TOWN OF HORIZON CITY Planning and Zoning Commission Staff Report

Case No.: Application Type: P&Z Hearing Date: Staff Contact: Address/Location: Legal Description:	SUC24-0002 Rancho Desierto Bello Unit Seventeen (RDB U-17) SUBDIVISION COMBINATION August 19, 2024 Art Rubio, Planner 915-852-1046 ext. 407 arubio@horizoncity.org The vacant parcel is located south of Claret Cup Road and west of Darrington Road. A portion of Leigh Clark Survey No. 297, Town of Horizon City, El Paso County, Texas, approximately 19.647 acres.
Owner:	Viva Land Ventures
Applicant/:	TRE & Associates, L.L.C.
Nearest Park:	RDB 2 Park
Nearest School:	Ricardo Estrada Middle School

Application Description:

Attachment 4- Preliminary Plat

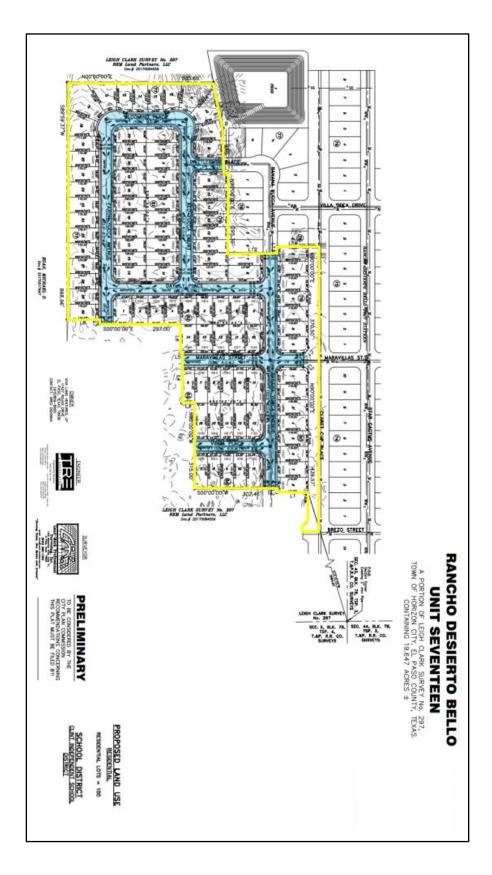
Please correct 34 lots that do not meet the minimum lot width required of 50 ft. for R 9 (Single-Family Dwelling) zoning district as marked on plat.

We did not find any lots that were exactly 6000 sf; therefore the minimum lot width did not apply to those lots. A comments was added to included the size of each lot below the lot number, as required.
